Re: The NIST Report On the Collapse of WTC Building 7
Challenged by 2,100 Architects and Engineers

The underlying issue stems from the official NIST Report (NIST NCSTAR 1-9-Nov. 2008) which basically contends that for the first time in history, the symmetrical, complete collapse of a large, fire protected, 47 story steel framed

Technical Discussion:

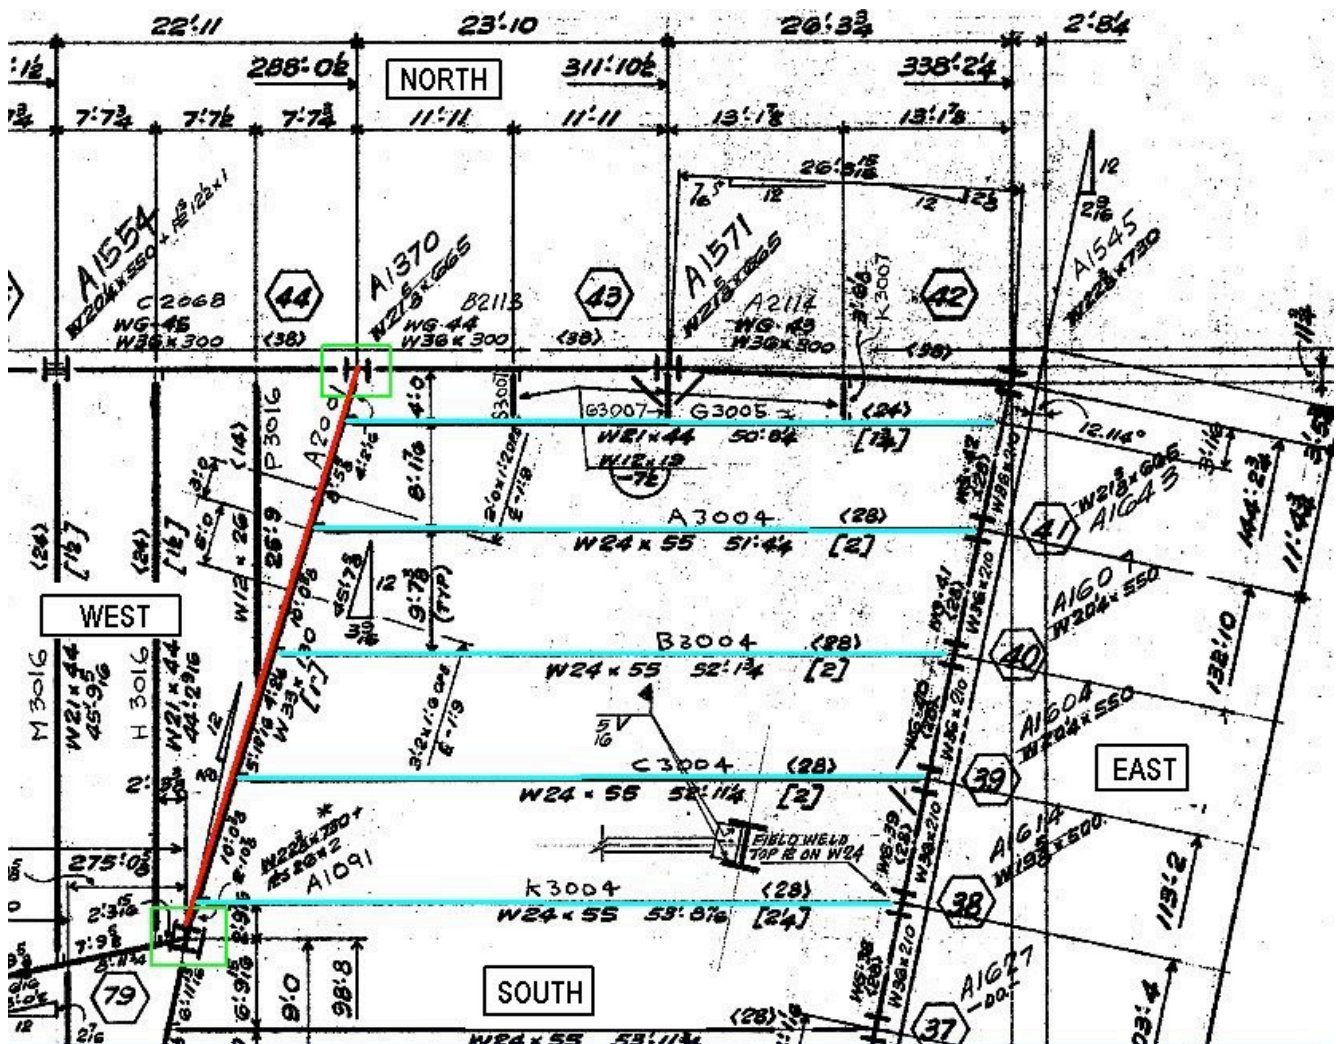
The NIST WTC 7 report claims the initiating event was that a critical girder (girder A2001) in the northeast corner of the building under the 13th floor was either pushed or rocked off its seats at exterior column 44 and corner core column 79 by thermally expanding beams framing into it from the east as shown in Figure 1.

**Figure 3: Plan View at Floor 13, Column 79 Seated Connection of Girder A2001.
(Data from Frankel Steel Limited, 1985b)**

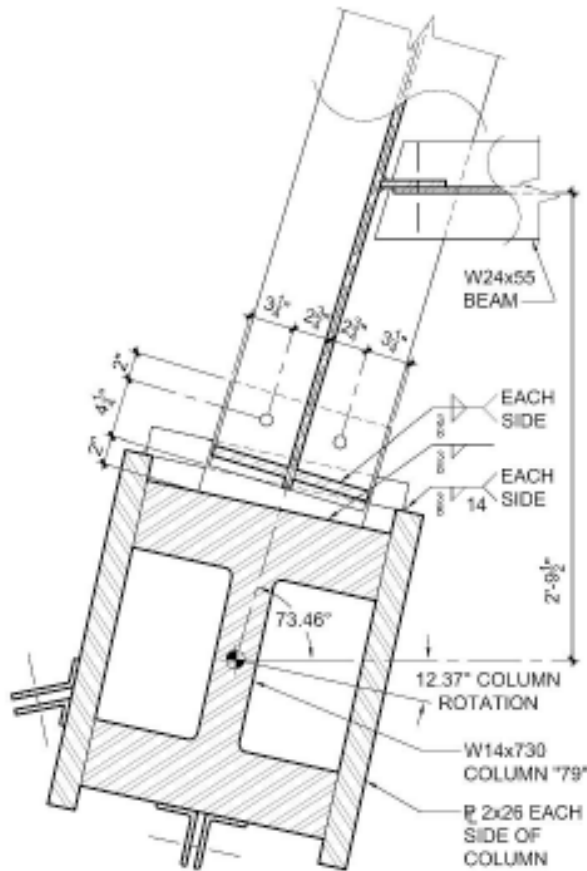
However, when calculated from the provided geometry and details of the girder and seat shown in Frankel drawings #1091 and 9114 the axial bearing length of the girder on the seat is seen to be 6.25 inches as shown in Figure 3 below.

So it is unclear how the 5.5 inch axial travel distance for walk-off was determined as it is not related to bearing length. If it is due to when the seat would fail it needs to be stated.

However, the most serious issue that the erratum does not explain is how the additional beam expansion for a 6.25 inch lateral walk-off travel distance would occur. This is confounding as the 5.5 inches, previously given for lateral walk-off distance, is the maximum axial thermal expansion of the 53 foot long beams at the 600 °C temperature they were claimed to be heated to in the report. The NIST needs to explain why this greater expansion seems to have simply been assumed to occur. Otherwise, they need to update their thermal analysis to show significantly higher beam temperatures could have existed. They also need to provide beam deflection

Figure 4: Plan View of east side exterior beam to column connections from Frankel drawing #9101.

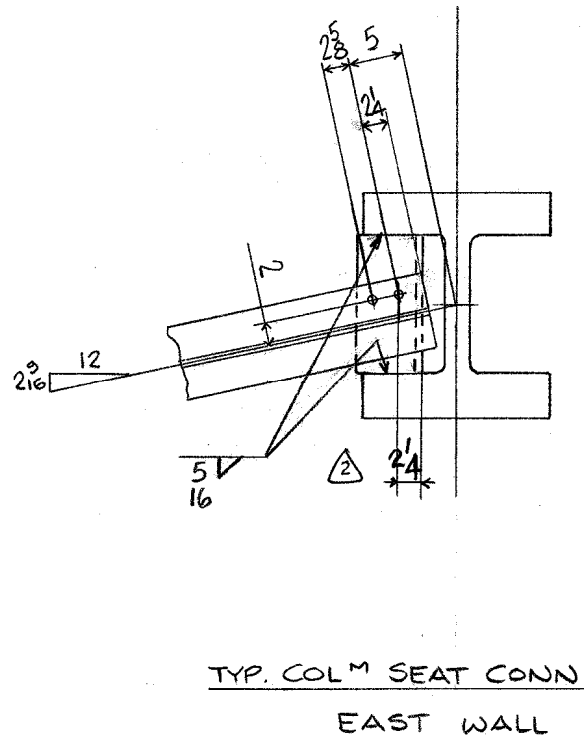
The above also assumes that all of the expansion was directed westwards, and that the four bolts of the beam connections to the columns at the east side exterior would withstand the breaking of the 28 shear studs on the beams. The beam to exterior column connections also contained clearance between the beam and the columns as shown in Figure 4, so if the bolts broke there would be at least an inch of movement to the east. This is not discussed in the NIST WTC 7 report.

Figure 5: Side View of Column 79 Seated Connection of Girder A2001 on Frankel Drawing #9114.

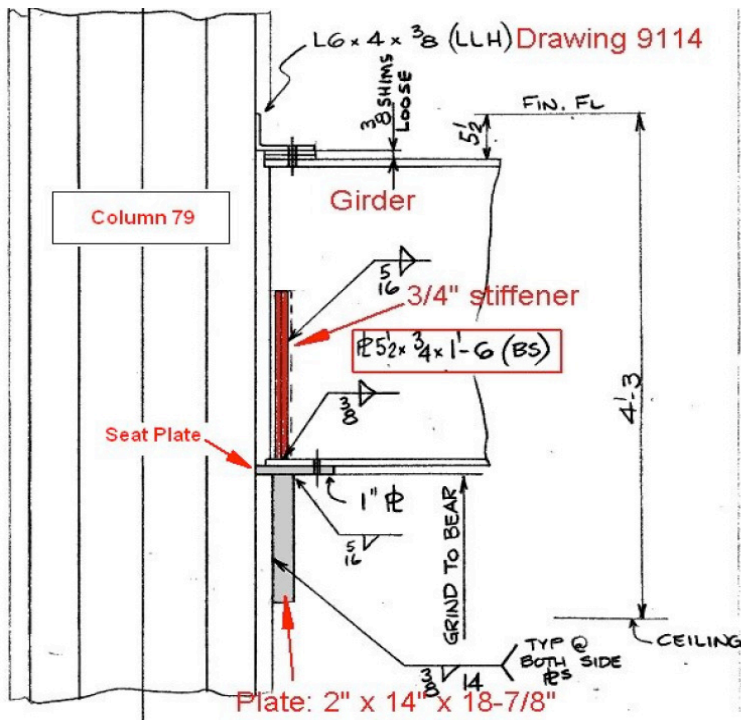
Although the shop fabrication drawing for girder A2001 has not yet been released, the stiffeners at the column 79 end of the girder are clearly shown on Frankel drawing #9114 as seen in Figure 5 below.

B) Given that Frankel drawing #9114 shows 3/4" web/flange stiffeners installed on the girder at the 13th floor column 79 connection, why weren't the stiffeners reported in NCSTAR 1-9 and shown in the figures listed above? Was Frankel Drawing #9114 used? If not, why not?

The web stiffeners shown at the end of the girder in Frankel drawing #9114 prevent web crippling. The structural analyses of WTC 7 did not show any web crippling failures. Therefore, the web crippling plates did not need to be included in the models/analyses. Again, we apologize for the length of time it took to get this information back to you. Thank you for your interest in the NIST World Trade Center investigation.

Figure 7: Typical depiction of the girder end at column 79 in the NIST WTC 7 report.

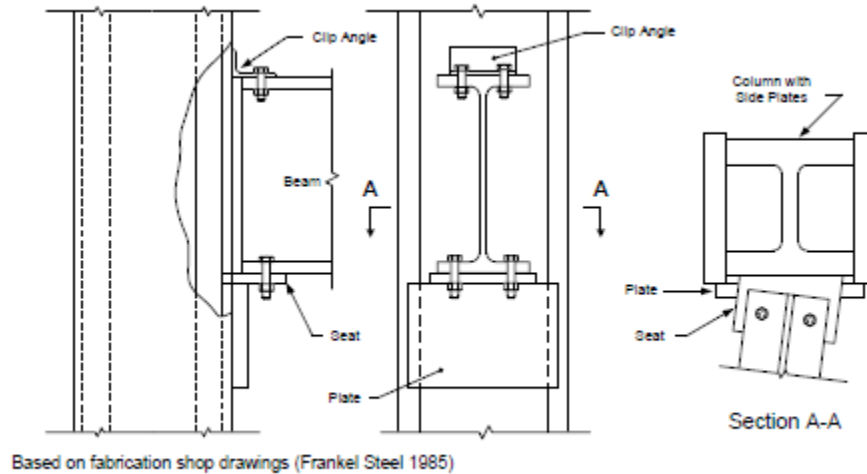
Figures 7 and 8 show how the girder was depicted without stiffeners in the NIST WTC 7 report and that the stiffeners were not included in the analysis model of the connection used to support the conclusions of the report.

Figure 9: The A2001 girder connection at column 79 with the girder stiffeners depicted as they should have been in the NIST WTC 7 report per Frankel drawing #9114.

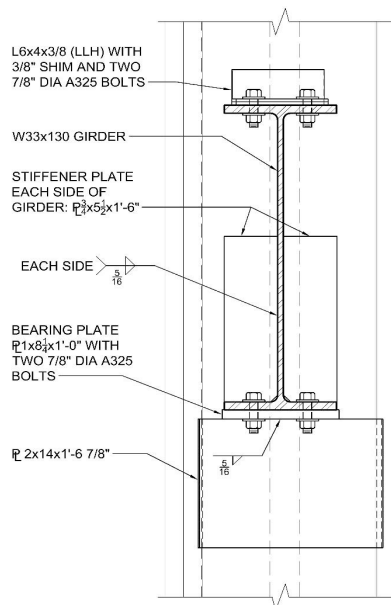
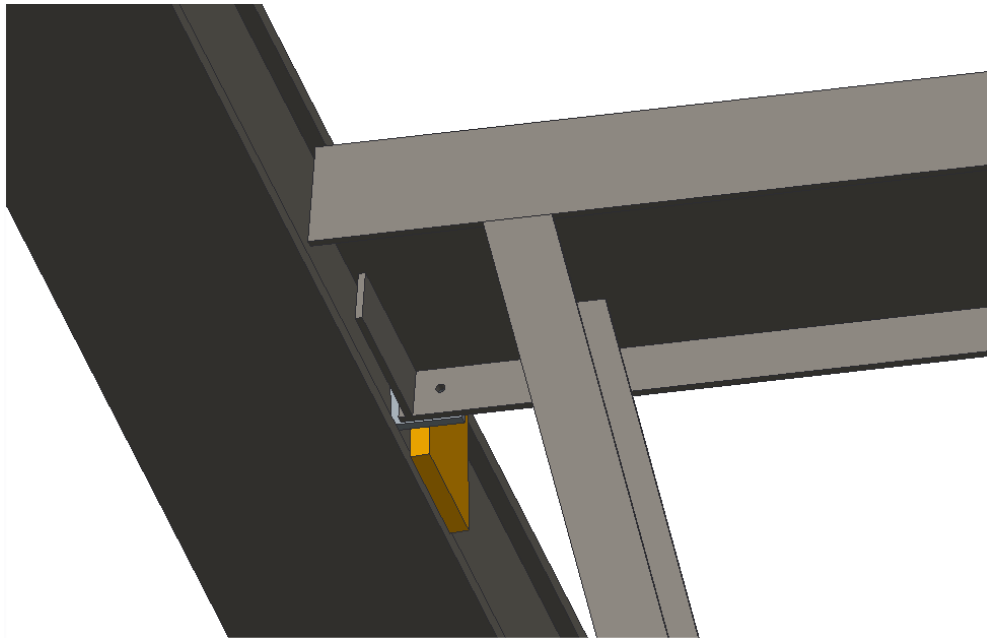
Figure 9 is an accurate to scale depiction of girder A2001's connection to column 79 showing the girder stiffeners based on Frankel drawing #9114. Figure 10 is an accurate to scale 3-D rendering of the connection.

Figure 11: Analysis showing the girder flange does not fail when the web is beyond the seat with stiffeners installed. The above is with 6.75 inches of beam expansion.

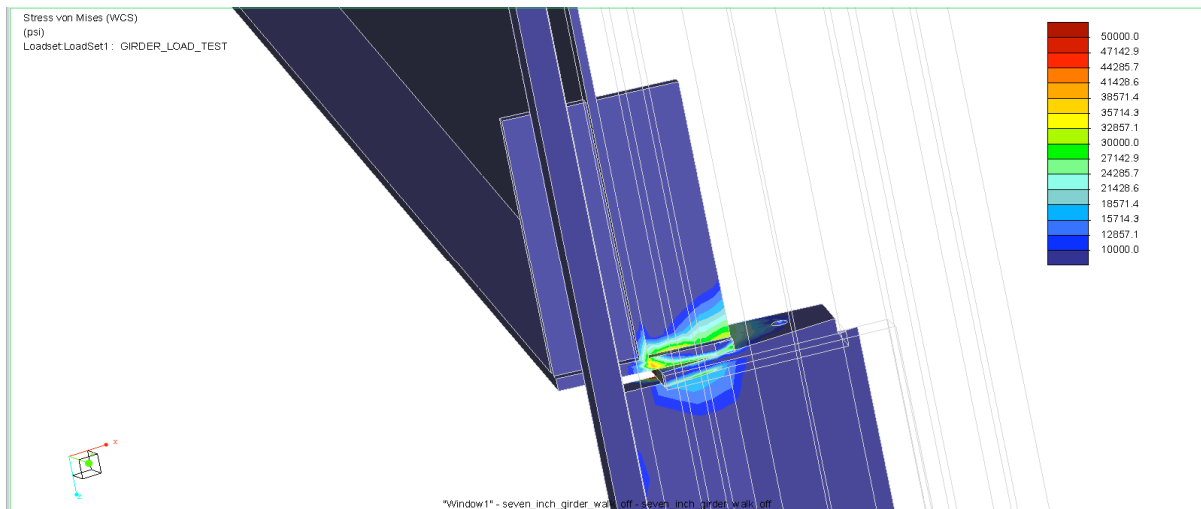
The stiffeners would have done more than simply prevent web crippling as they also strengthen and stiffen the flange. Figure 11 shows the results of an analysis with the girder web beyond the seat with stiffeners included. The stress on the flange and stiffeners is well below yield strength showing the stiffeners would prevent failure of the flange of the girder even if the web was pushed beyond the 12 inch wide seat. In reality, the centered girder web could not move beyond the edge of the 12 inch long seat due to the 5.5 inch beam expansion maximum.

Figure 12: Three W12 x 19 lateral support beams labeled S3007, G3007, and K3007 framing into beam G3005 are shown on Frankel drawing #E12/13 (the three beams are highlighted in green here).

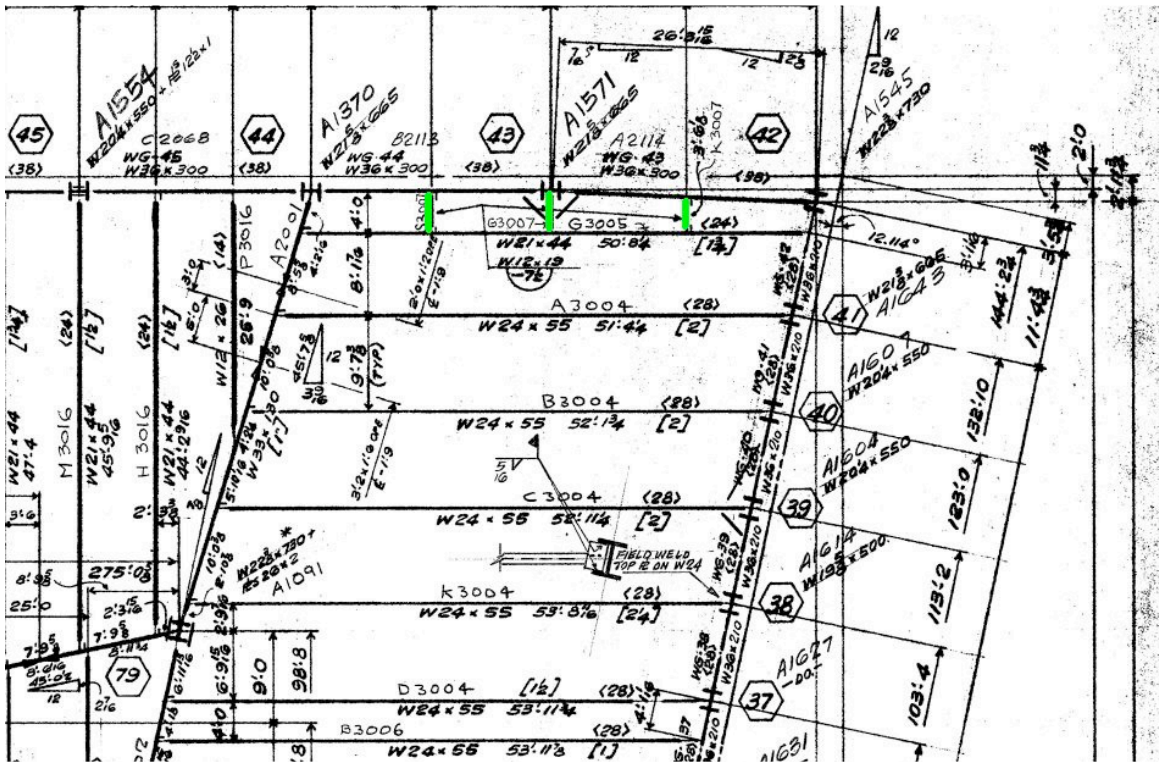
The omission of the lateral support beams from the exterior frame to beam G3005 has not yet been acknowledged, although the question concerning them was also asked in the FOIA letter to the NIST dated March 19, 2012. They can be seen in Frankel drawing #E12/13 as shown in a blow up from that drawing of the northeast corner at floor 13 in Figure 12 below.

Figure 13: Figure from the NIST WTC 7 report does not include the lateral support beams framing into beam G3005 from the exterior as shown on Frankel drawing #E12/13.

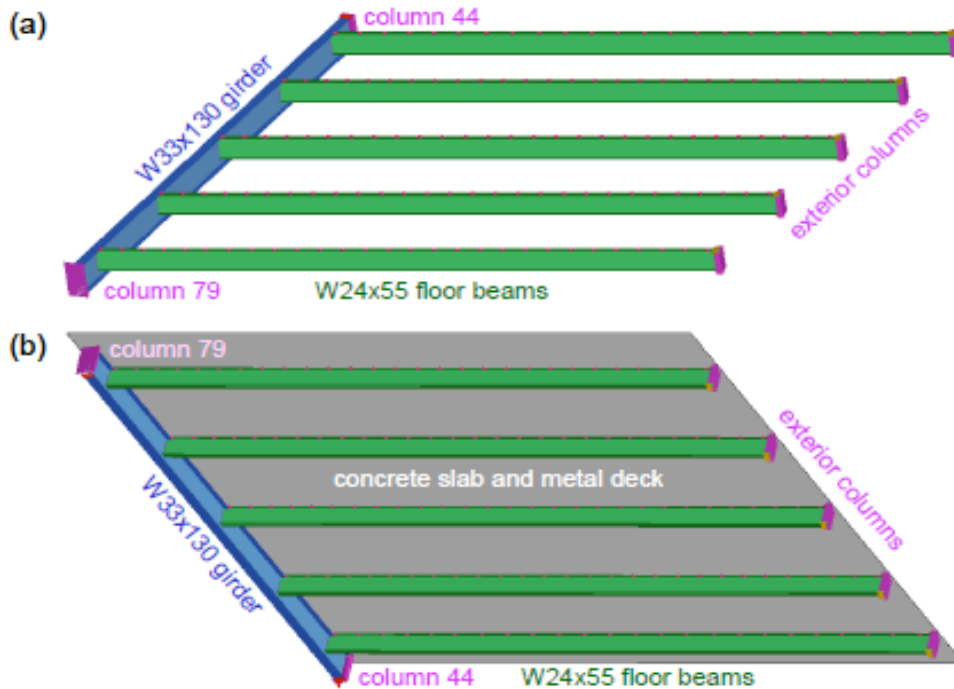
Figures 13 and 14 show the elements used in a second NIST analysis of the five floor beams and girder where beam G3005 is said to buckle due to its thermal expansion being restrained by girder A2001, to then lose its load carrying capacity, and subsequently cause the other four beams to buckle which then rocked the girder off its seats. While buckling of this beam, due to restraint from thermal expansion, is possible without the three lateral support beams framing into it, it is not possible when they are included. The lateral support beams drastically reduce the beam's slenderness and cause the required buckling force to be approximately 16 times greater than it is without them. The models from the NIST analyses do not include the lateral support beams.

Figure 15: Model showing the omitted lateral support beams framing into beam G3005 from the exterior as shown on Frankel drawing #E12/13.

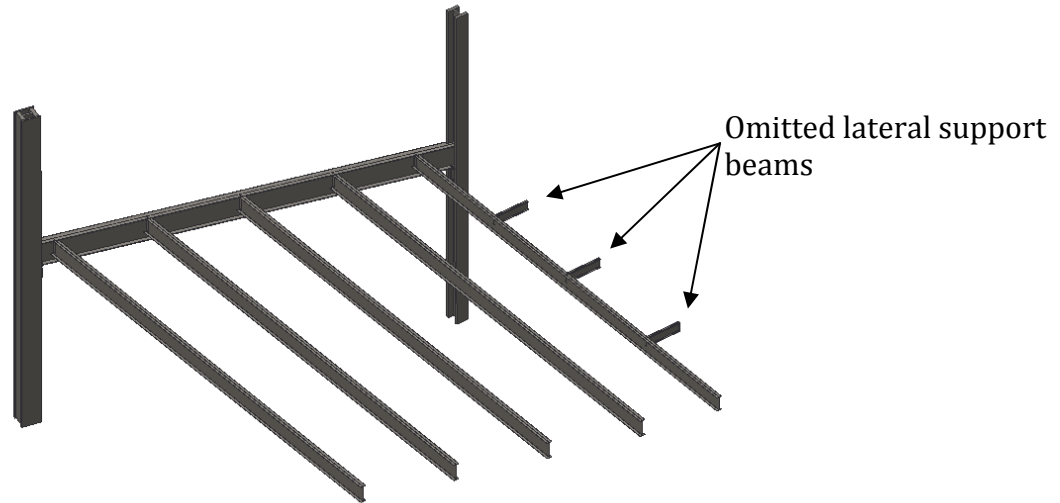
Figure 15 shows the floor framing under the 13th floor in the northeast corner with the omitted lateral support beams included.

Figure 16: Analysis results showing beam G3005 does not buckle with the three lateral support beams included when it is thermally expanded at 600 °C temperatures and girder A2001 heated to 500 °C temperatures per the NIST WTC 7 report.

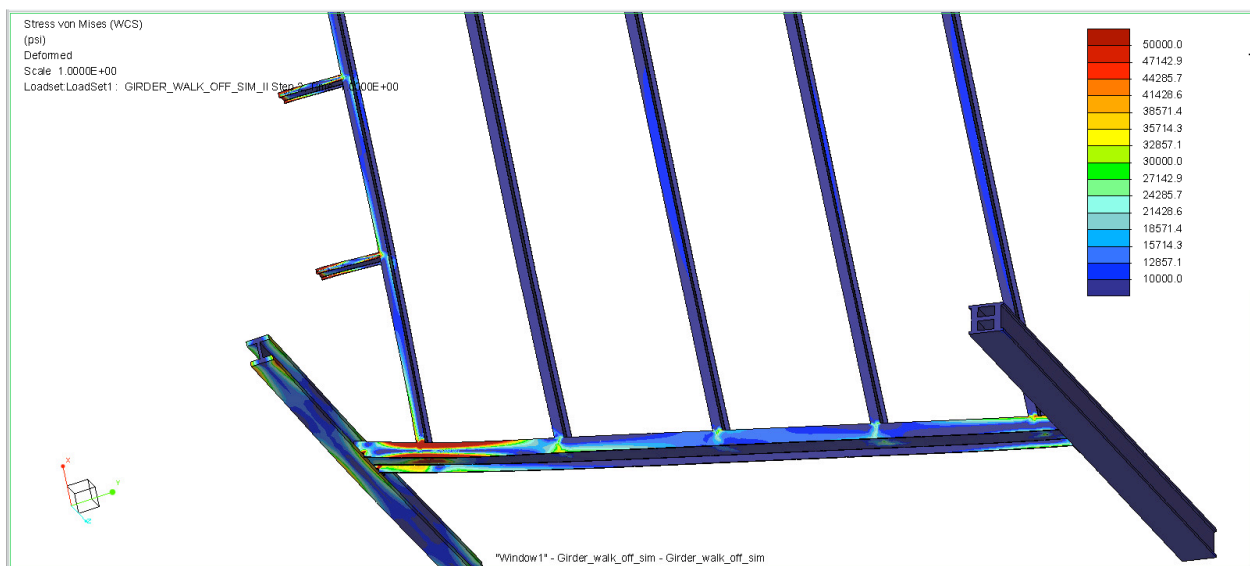
Figure 16 shows the results of an analysis performed with the lateral support beams included. It shows beam G3005 does not buckle when the three lateral support beams are included. This is due to the beam's slenderness being drastically reduced by having the lateral support and requiring approximately 16 times more axial compression to cause buckling. With the lateral support beams included the axial stiffness of beam G3005 is significantly greater than the girder's lateral stiffness and thus when the beam was thermally expanded it would have simply deflected the girder.
